MICHAEL DRISCOLL SCHOOL

OPM Monthly Project Update Report

January 2022

Change Order #8 Summary

7 MOCK-UP - ELEVATION 2
1/2" = 1'-0" 1/4 AS97

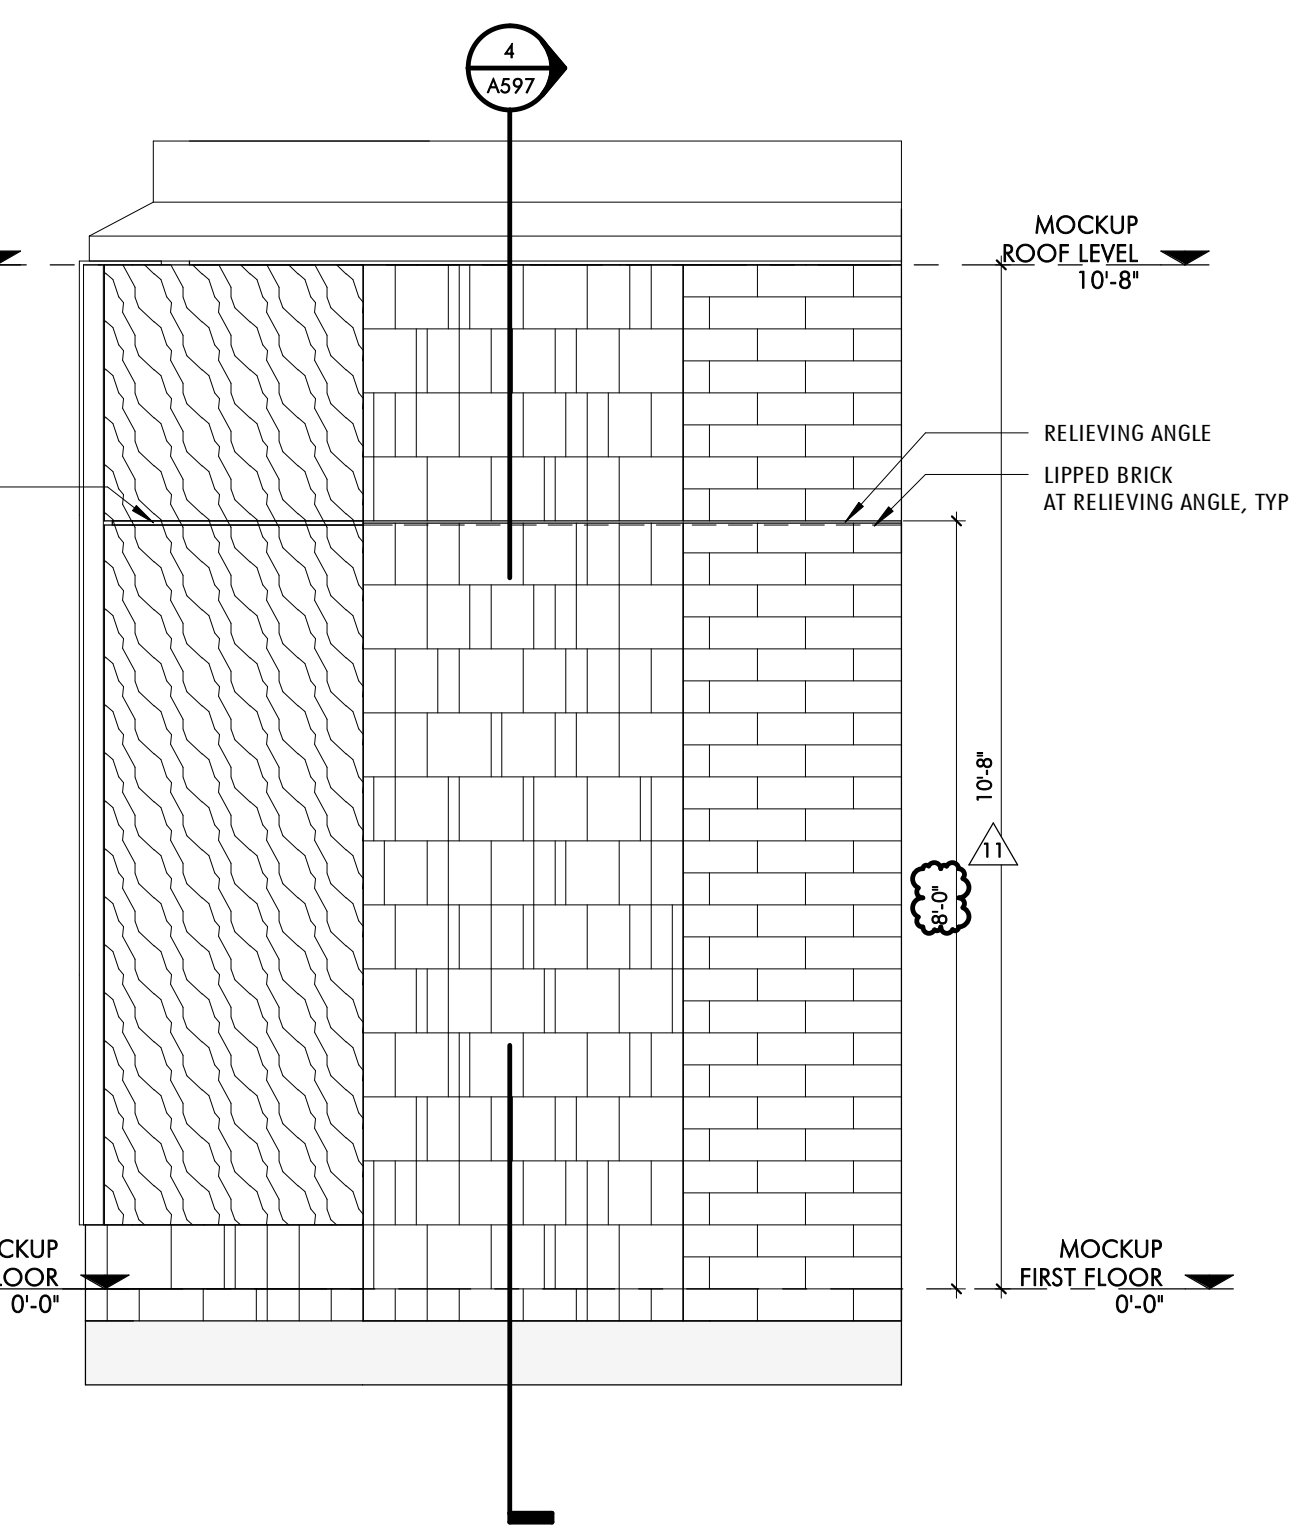
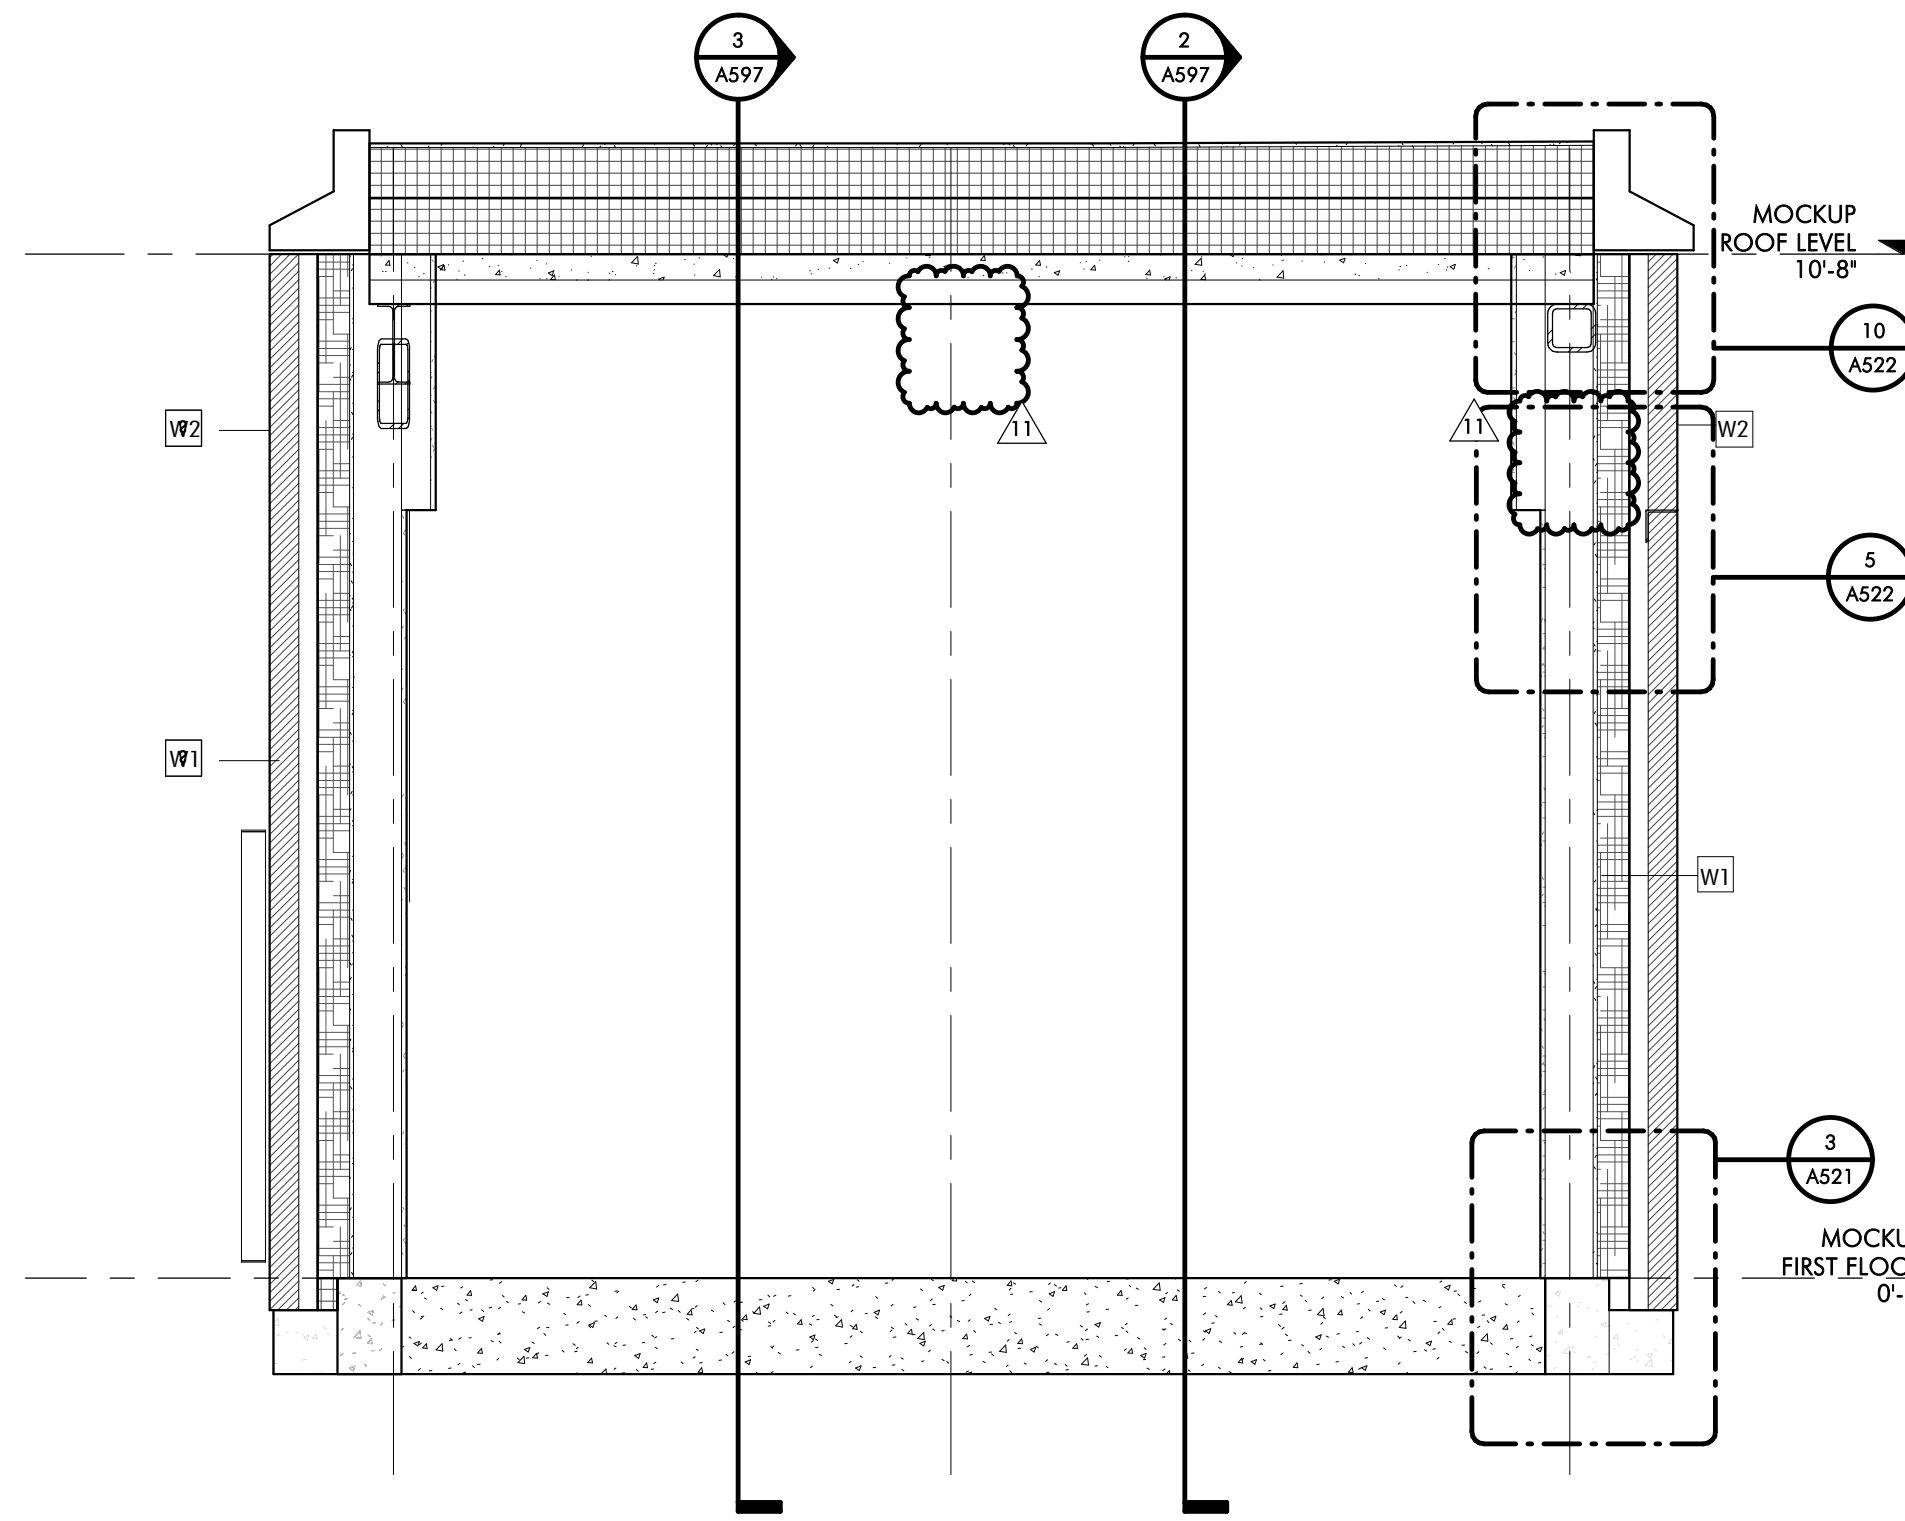
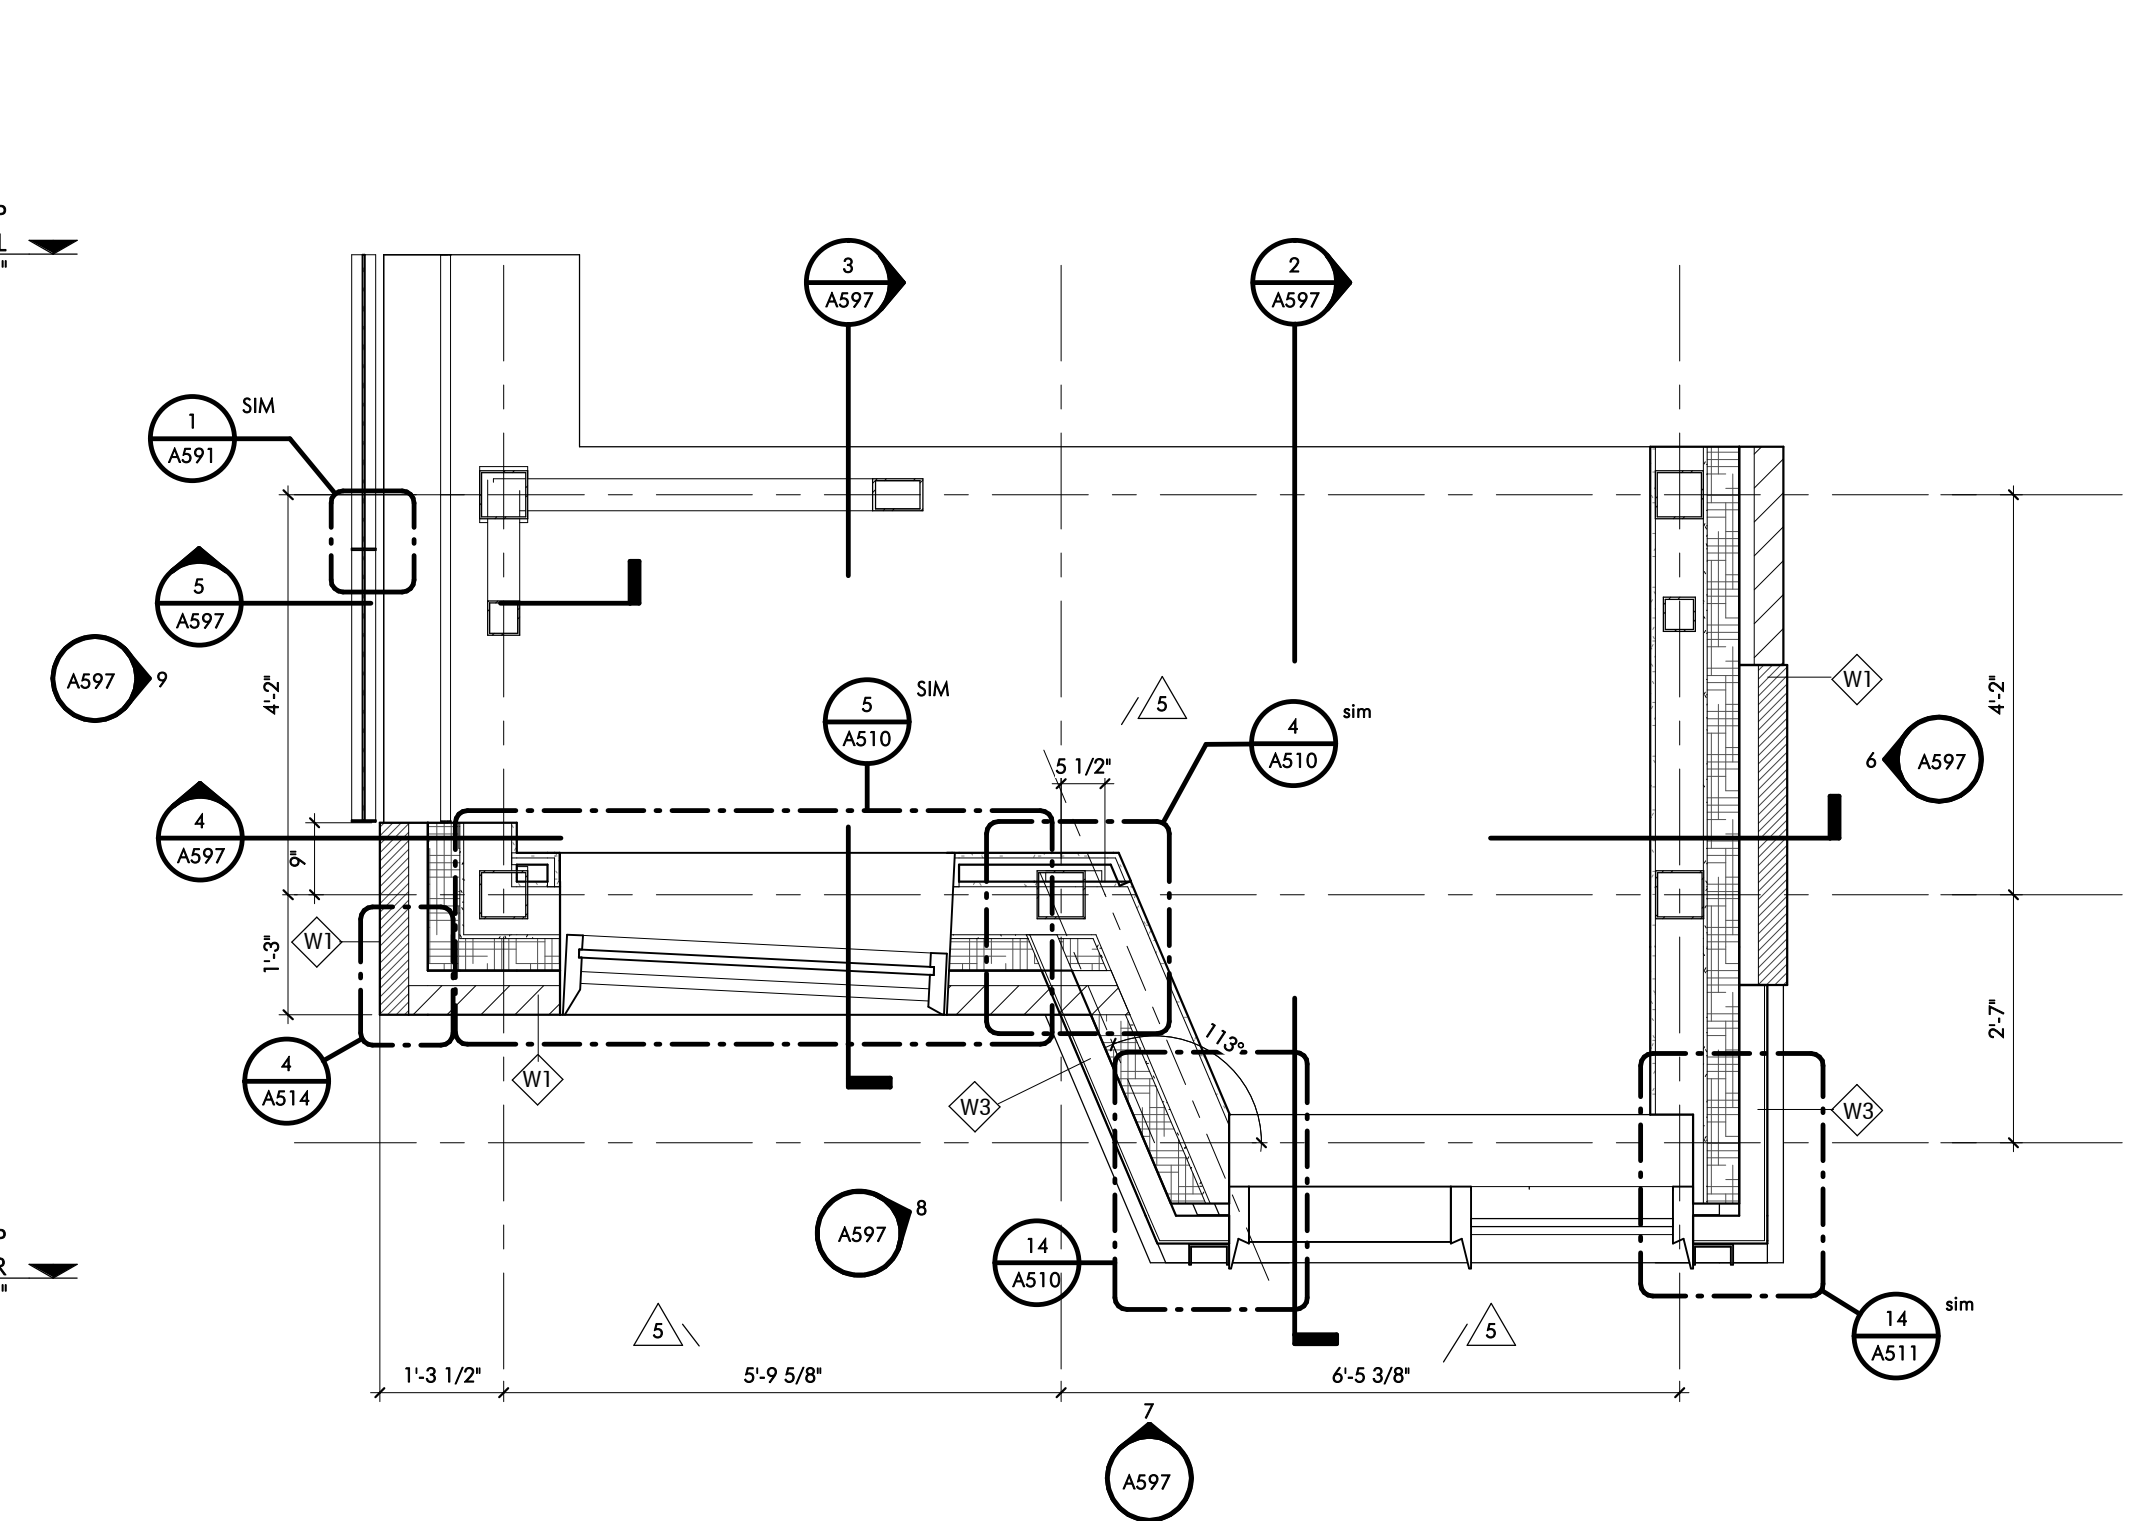
Revisions to Mock Up Drawing A597:

- Phenolic Panels in openings revised to metal panel to reflect contract documents detailing. Callouts added for plan details at metal panel.
- Exterior Materials legend updated to reflect contract documents and ASI 003R.
- Minor adjustments to dimensions and relieving angle joint elevation, as noted in submittal 05 12 00-00 review. WF and HSS steel on details 4 & 10/A597 revised to reflect comments submitted with mock up steel submittal 05 12 00-00.

1 TYP JAMB DETAIL AT CLASSROOM WINDOW (REF 5/A510)
 1 1/2" = 1'-0"

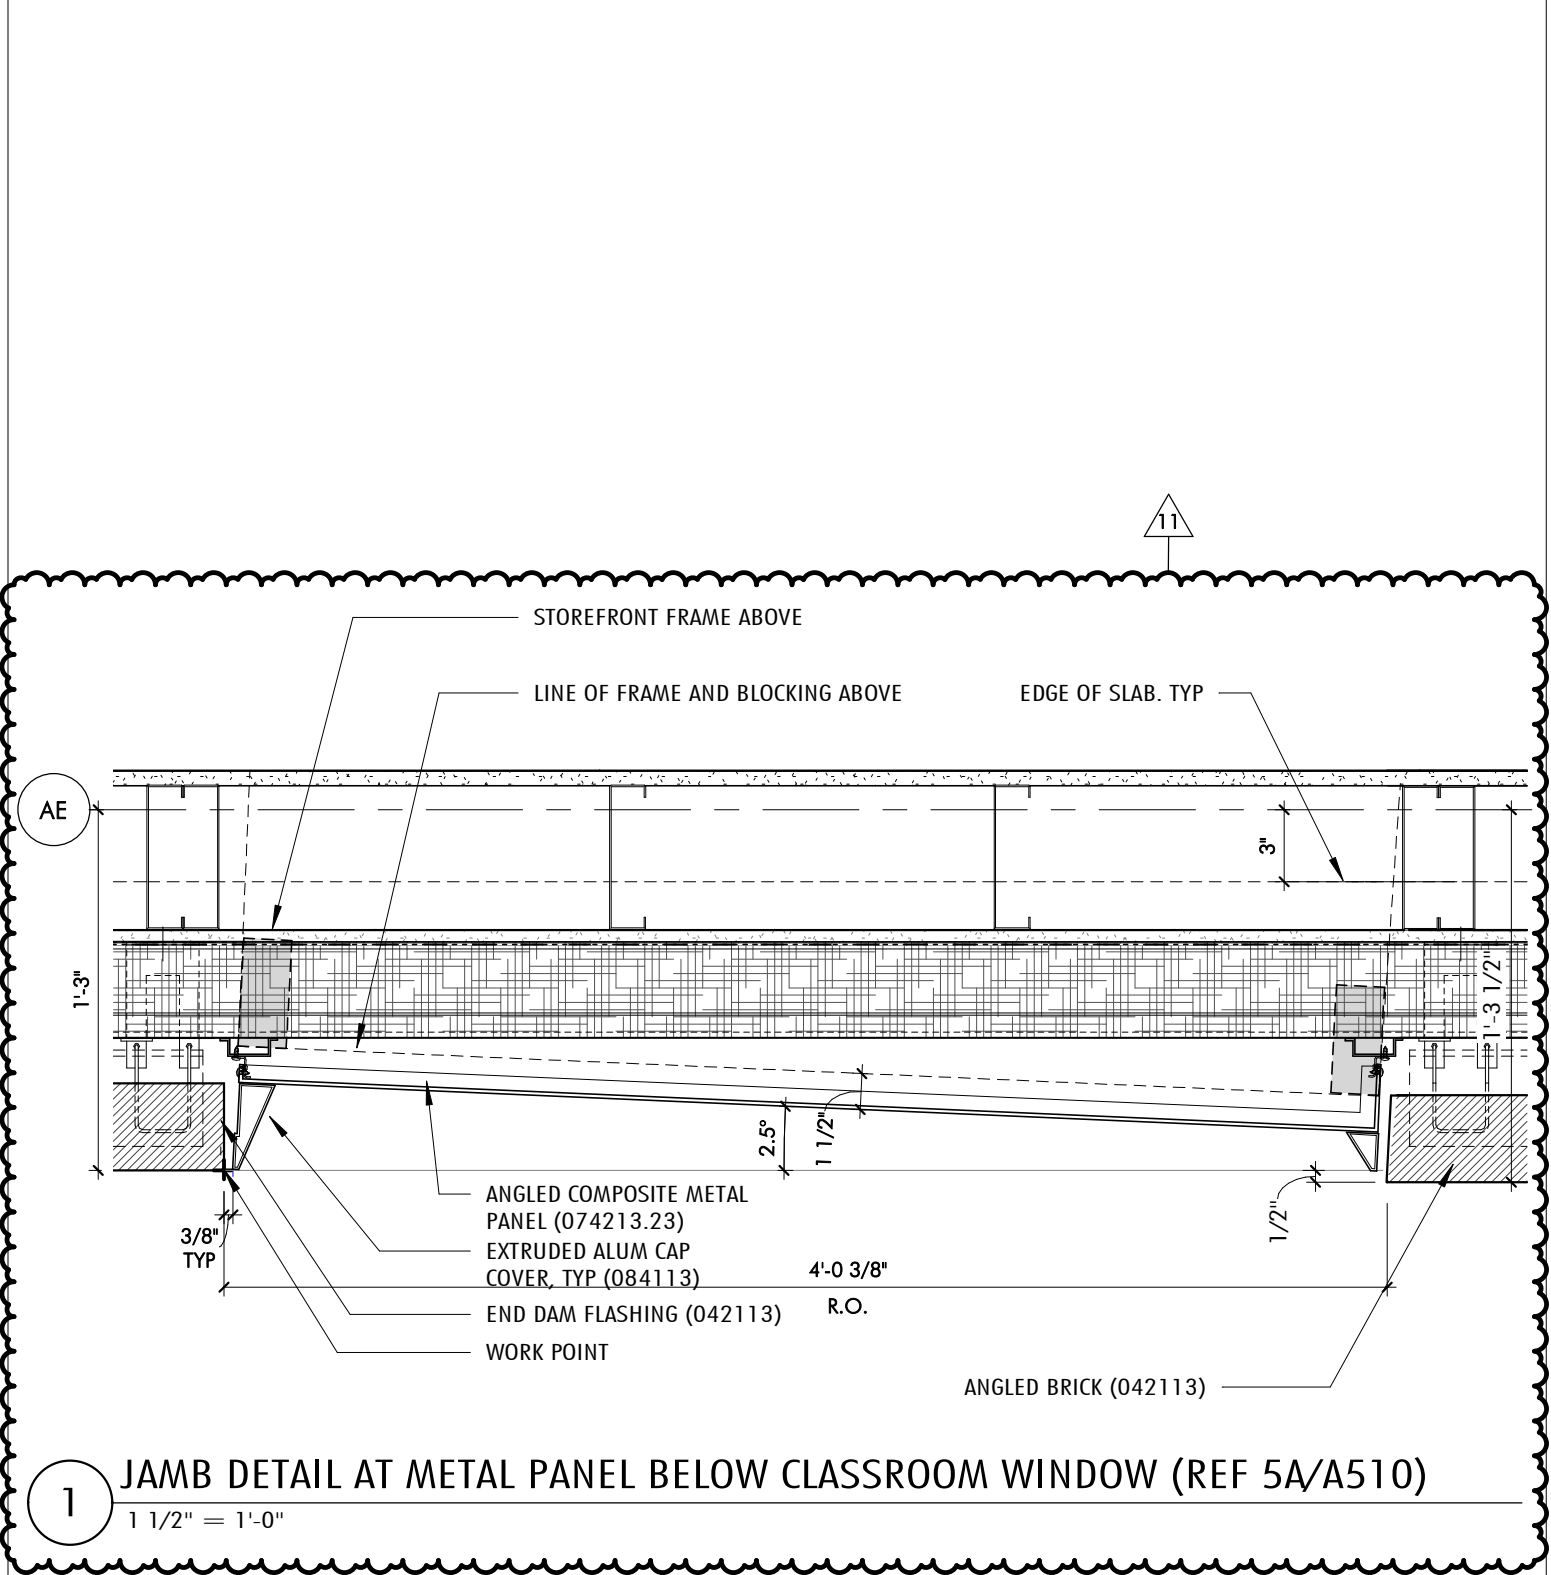
- A SK 016: typical plan detail of metal panel below/above window bay sill.
- A SK 017: typical plan detail of metal panel below/above angled classroom window.
- A SK 018: Angle of glazing in detail 5/A510 revised from 4 degrees to 2.5 degrees. Extruded aluminum cap covers relocated to align with face of brick/work point.
